RE: Minor Amendment to Prior Approval for Project 2018-001280; SI-2018-00049

The purpose of this letter is to request approval of a Minor Amendment to the Markana Apartments II Site Plan – DRB (PR-2018-001280) to align the plan with a proposed cap on the parapet that adds to the architectural interest of the buildings. This cap increases the overall maximum height of the buildings by 8 inches from 45 feet to 45 feet 8 inches. This amounts to an increase in building height of approximately 1.5%. The subject site is legally described as Lot 1-A, Block 28, North Albuquerque Acres Tract A, Unit B containing approximately 4.4 acres located at 6201 Alameda Boulevard NE.

MARKANA APARTMENTS - II
SAN PEDRO AND ALAMEDA
Albuquerque, New Mexico

BUILDING TYPE 2 AND 3
ELEVATIONS

1 - FRONT ELEVATION

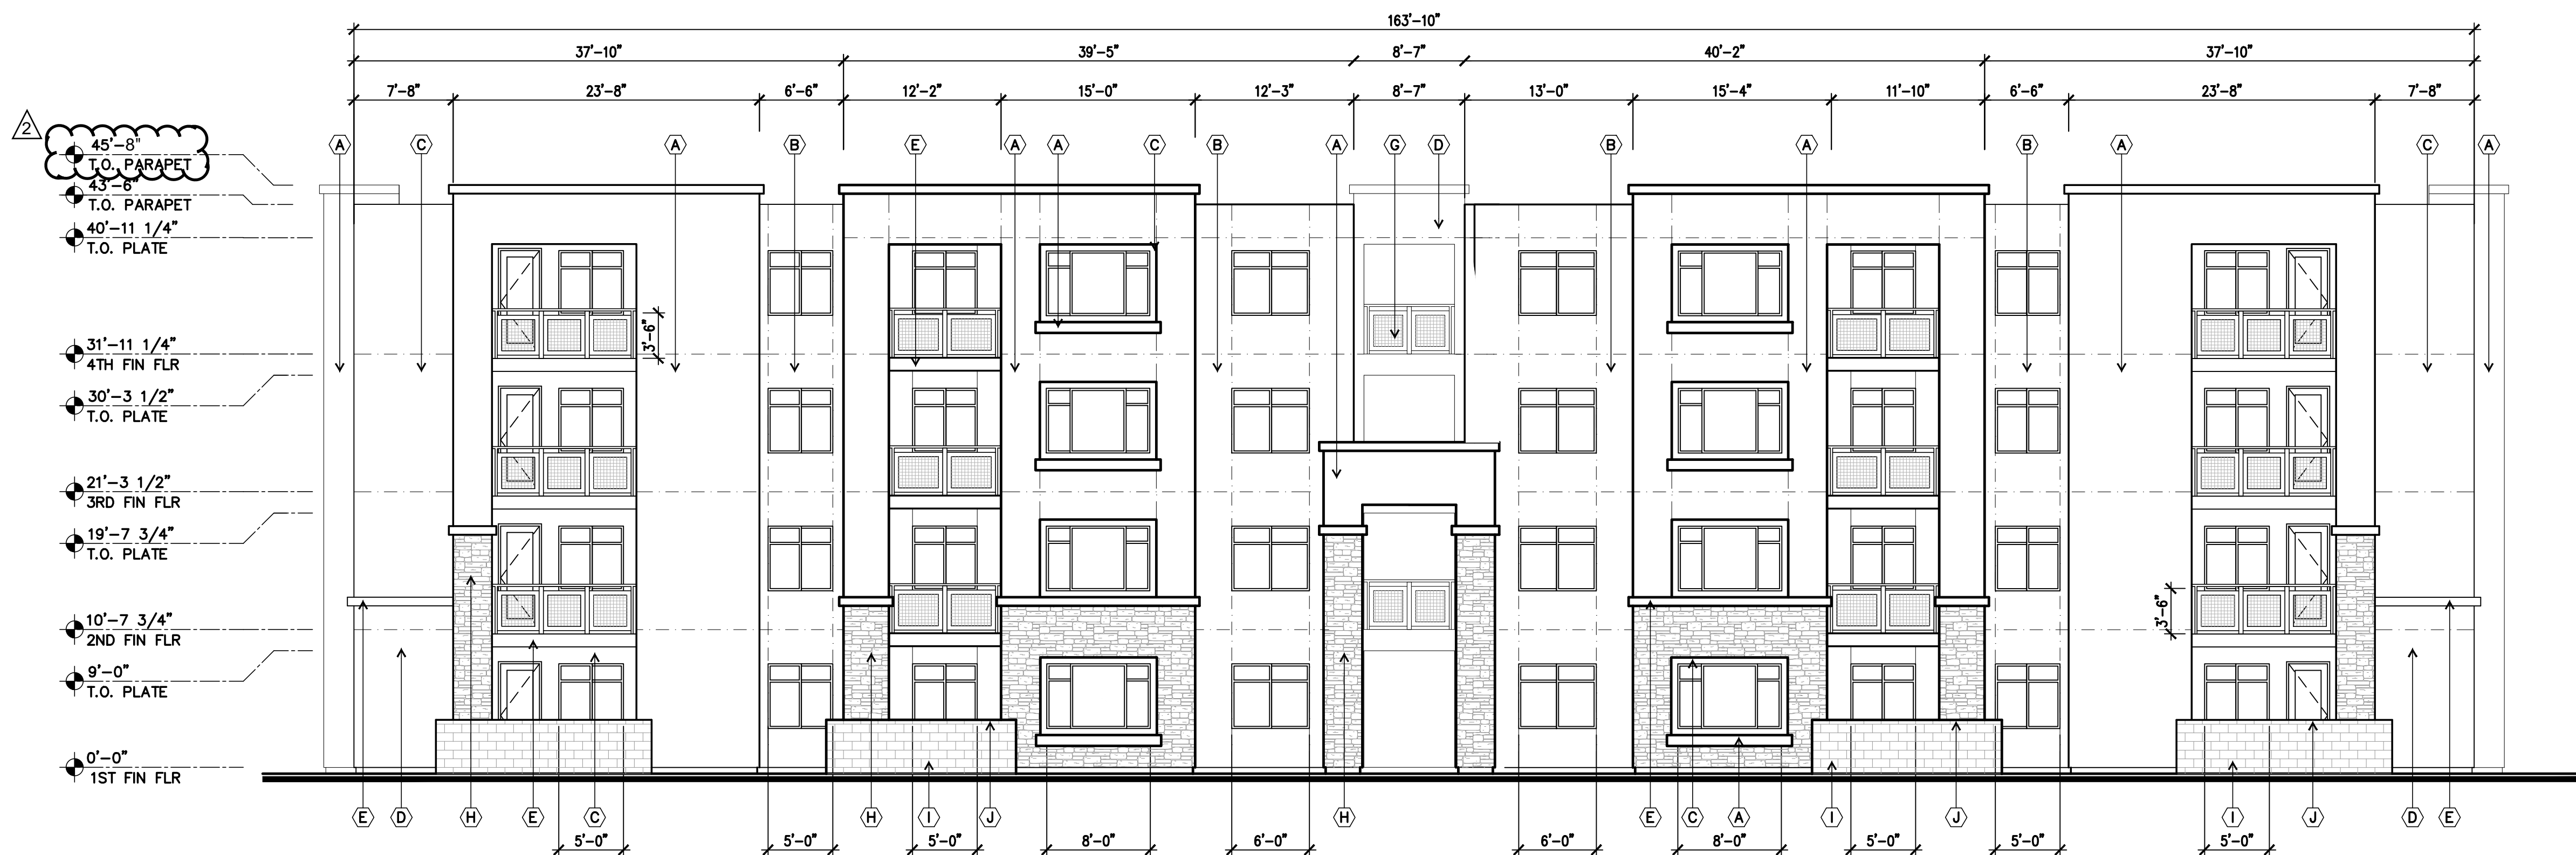
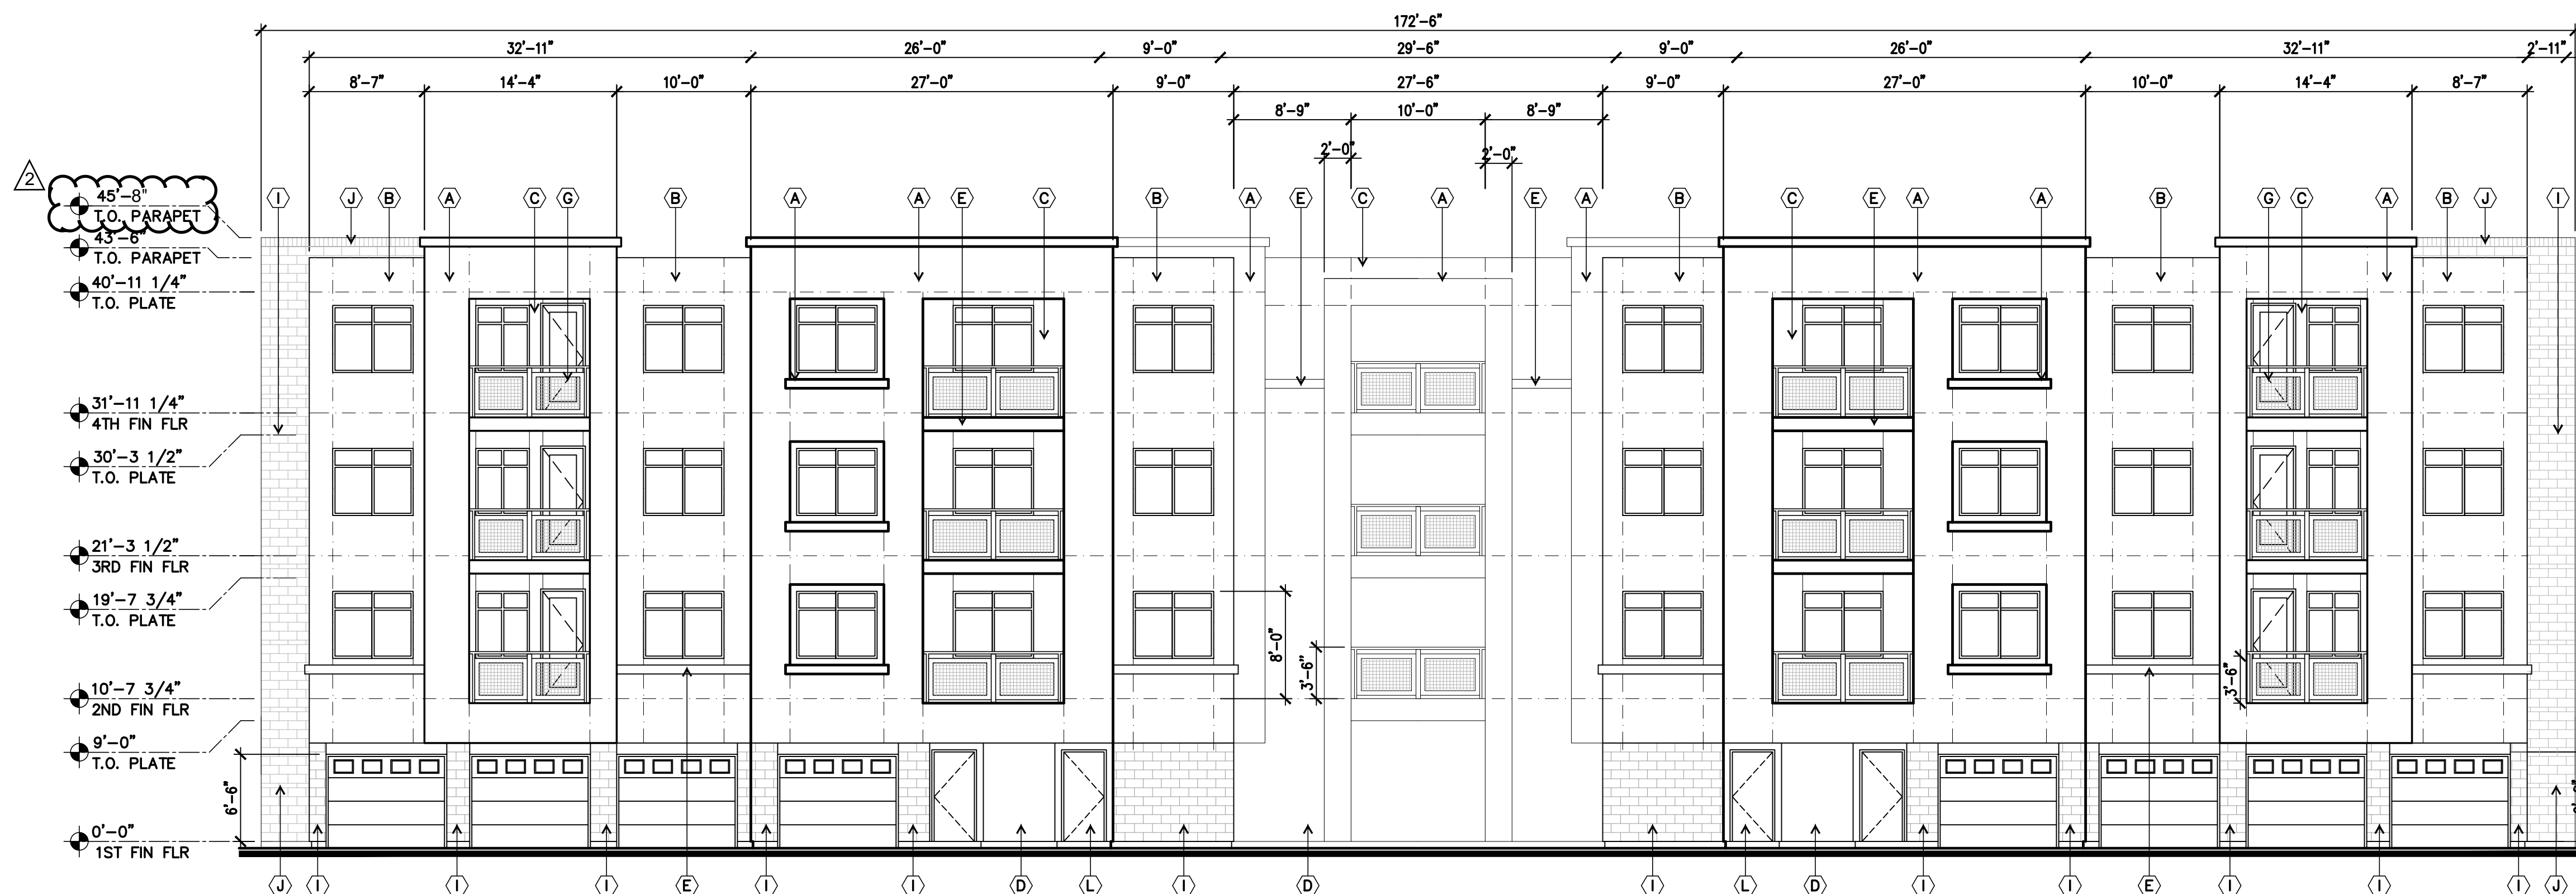
Amendment 04/22/2021:
Increased building height;
consistent with the RM-H Zone

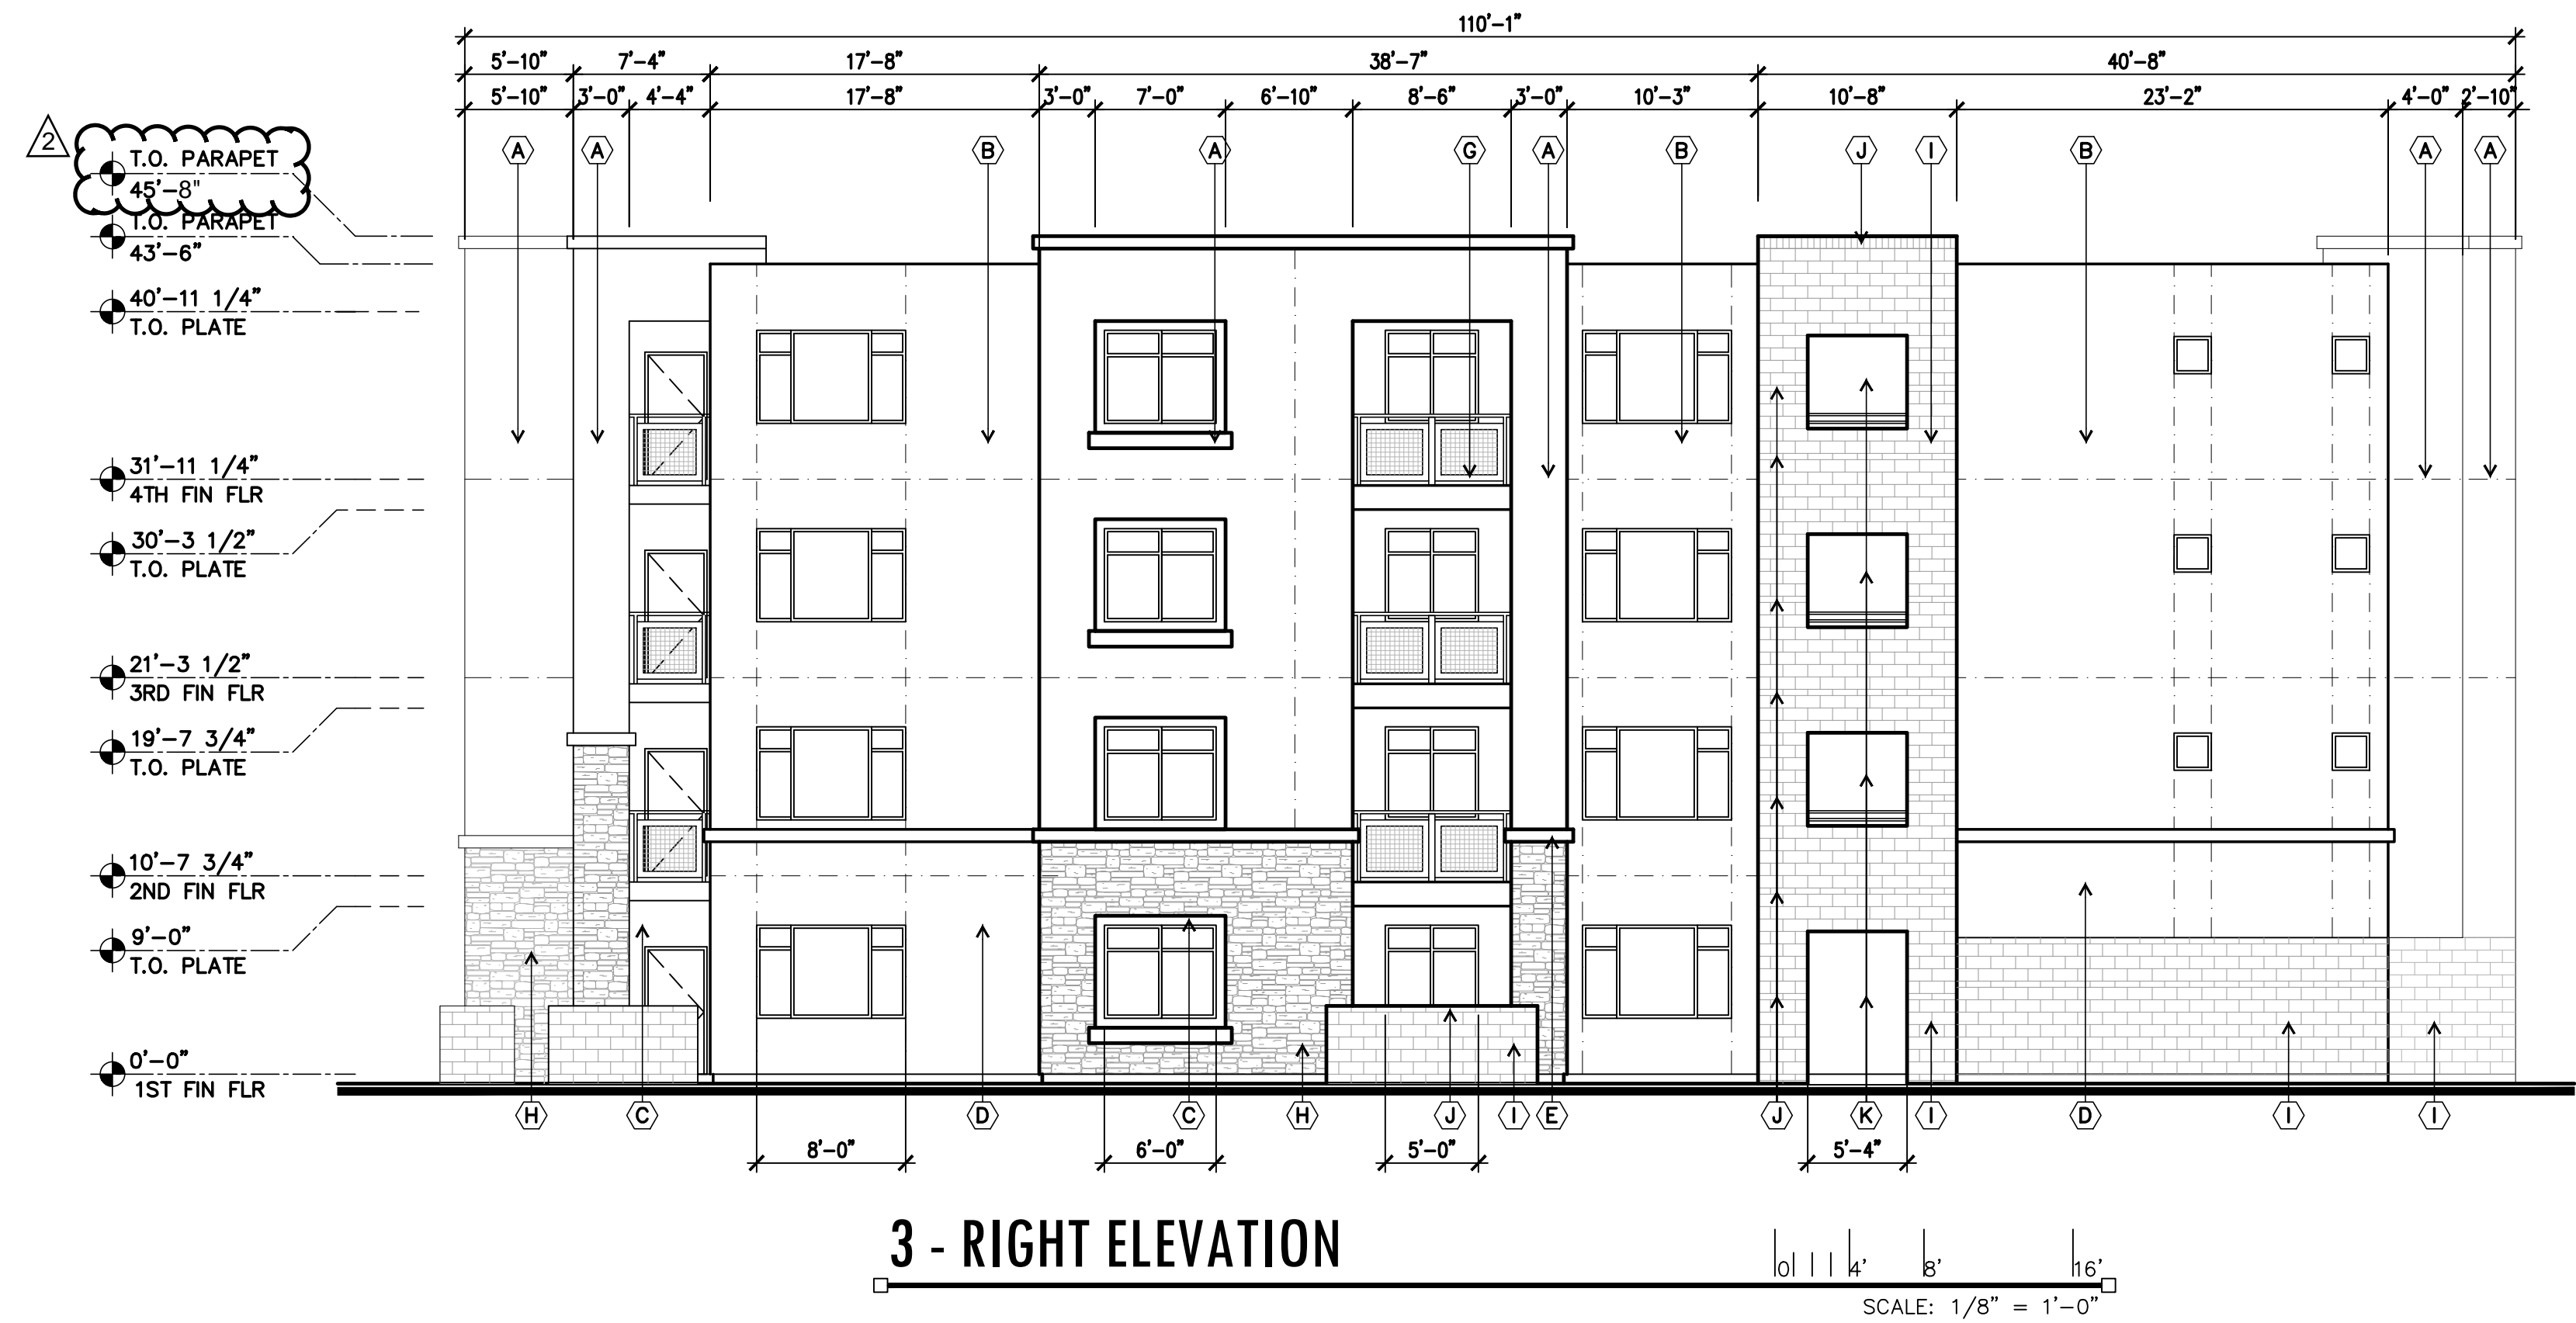
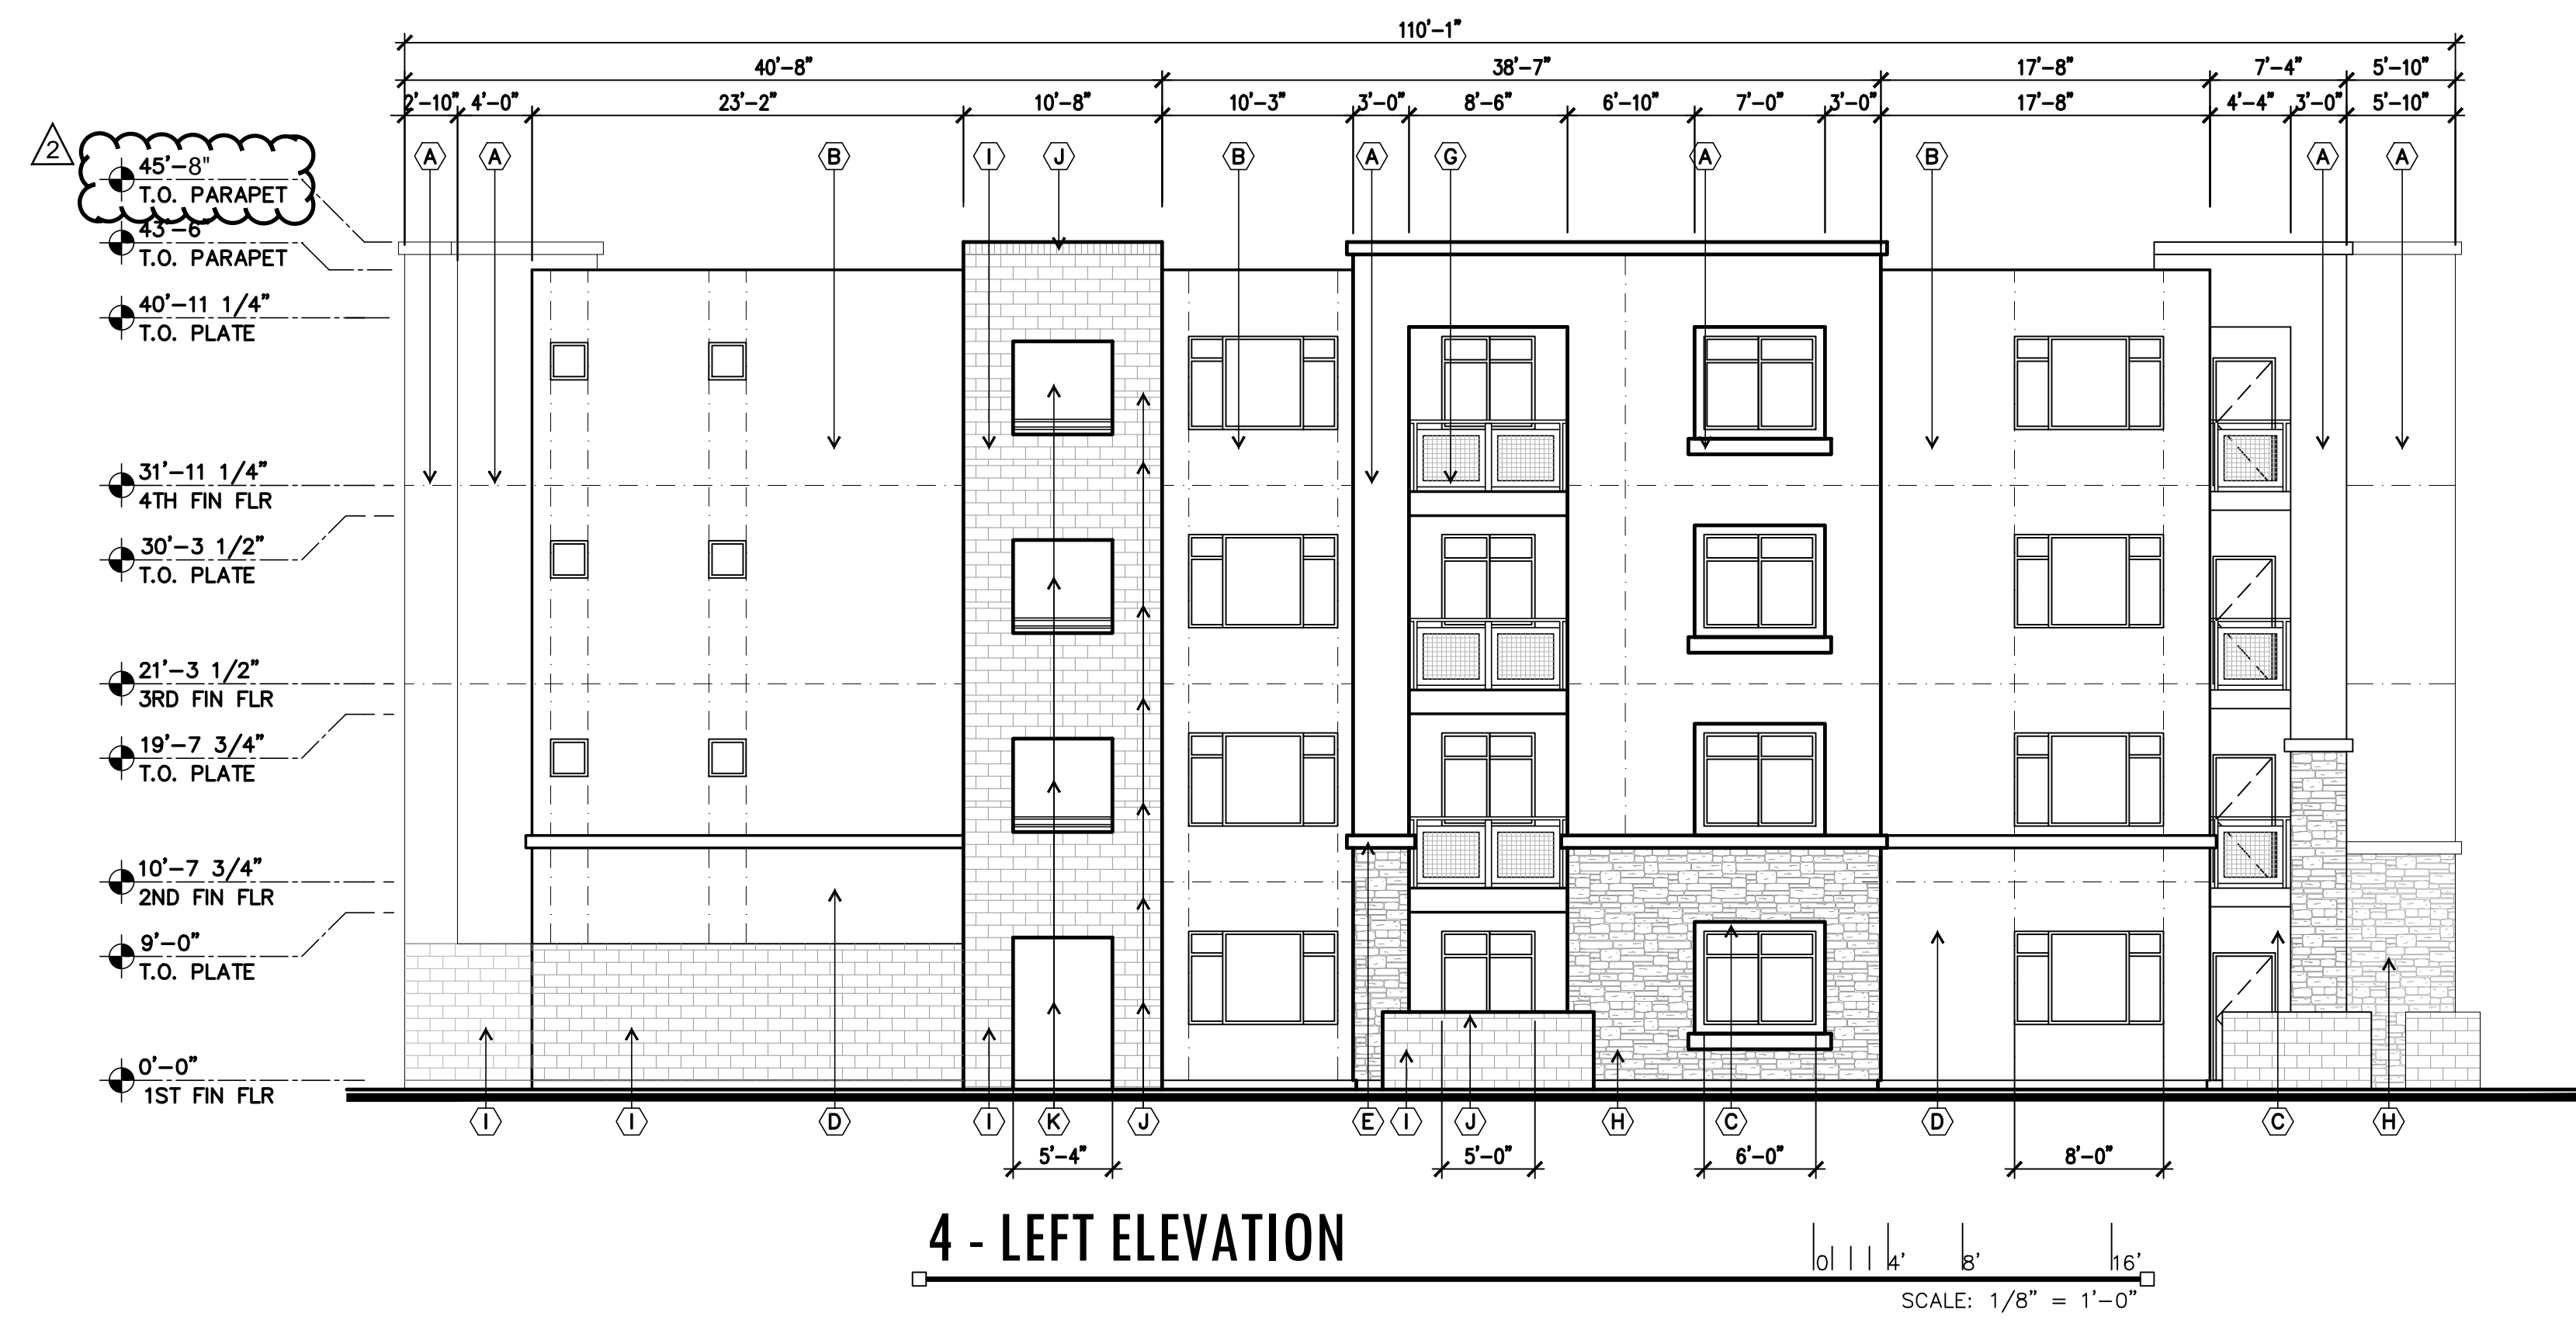
Amendment 04/22/2021:
Increased building height;
consistent with the RM-H Zone
